## 2009 Mercedes Benz Truck ML 350 (164.156) V6-3.5L (272.967)

Campaign No. 2012070002, November 2012

Retrofit Adapter Wiring Harness on [Camshaft](#) Adjustment Solenoids

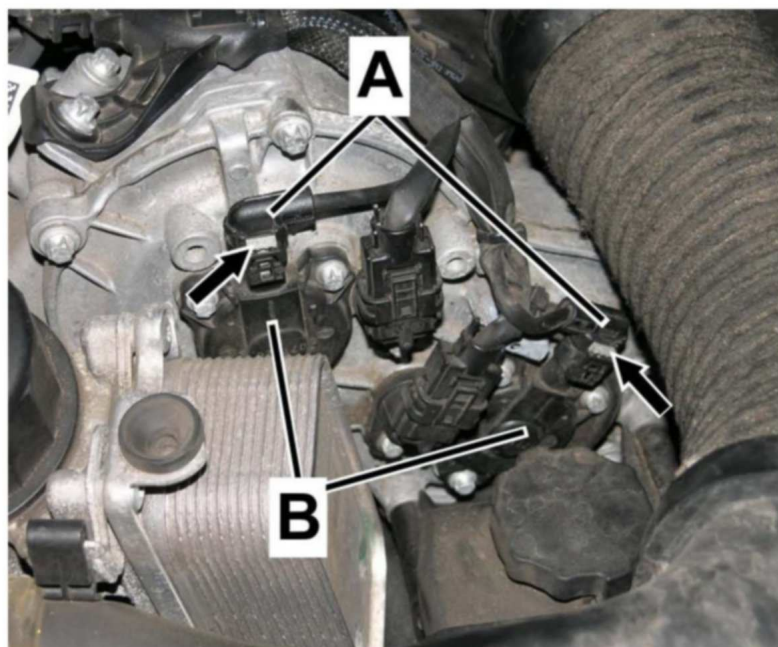
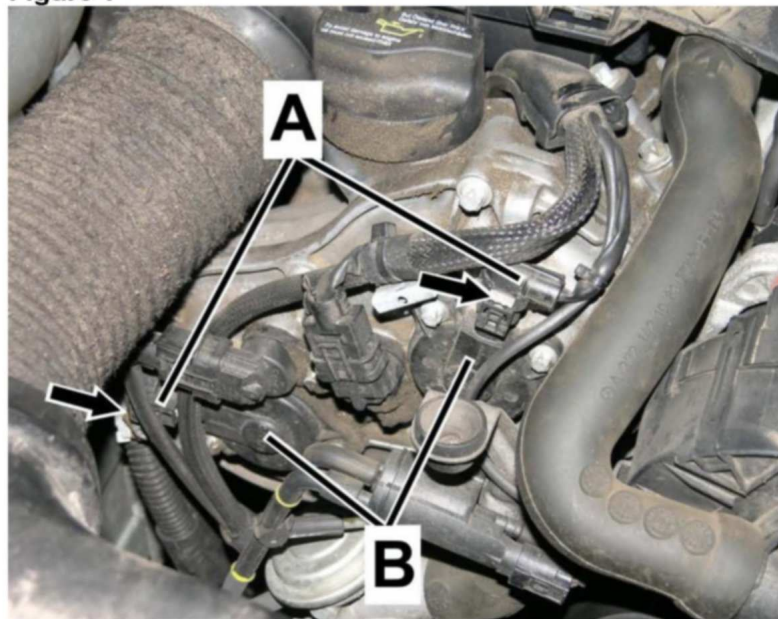
2. Disconnect **camshaft** adjustment solenoids from engine harness connectors (A, Figures 1 and 2) shown above.

^ Carefully unlock engine harness connectors (A) by squeezing and partially pulling out locking tabs (arrows) using pocket screw driver.

^ Disconnect **camshaft** adjustment solenoid connectors (A) from camshaft solenoids (B).

^ Push locking tabs (arrows, Figures 1 and 2) into connectors to secure (total of 8 locking tabs).

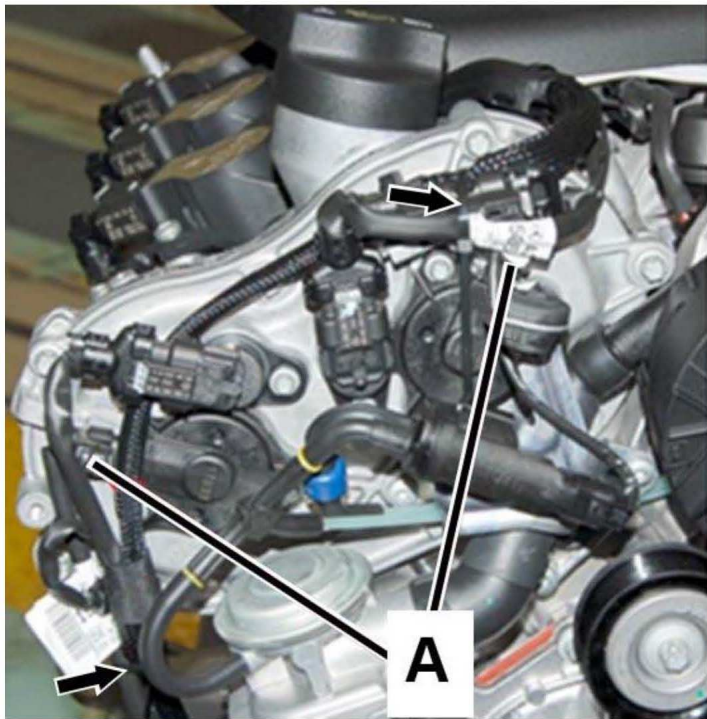
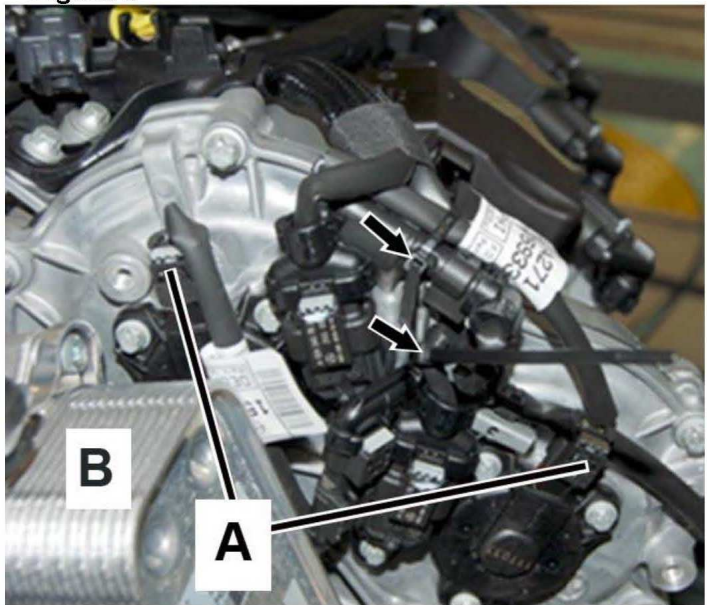
3. Connect adapter harnesses (A, Figures 3 and 4) shown above.

^ Connect adapter harnesses (A) between connector on **camshaft** adjustment solenoid and engine harness.

**Note:** Ensure harness adapters are properly secured using cable ties (arrows, Figures 3 and 4) to prevent wire chafing and/or damage from hot engine parts, (e.g. oil cooler [B]).
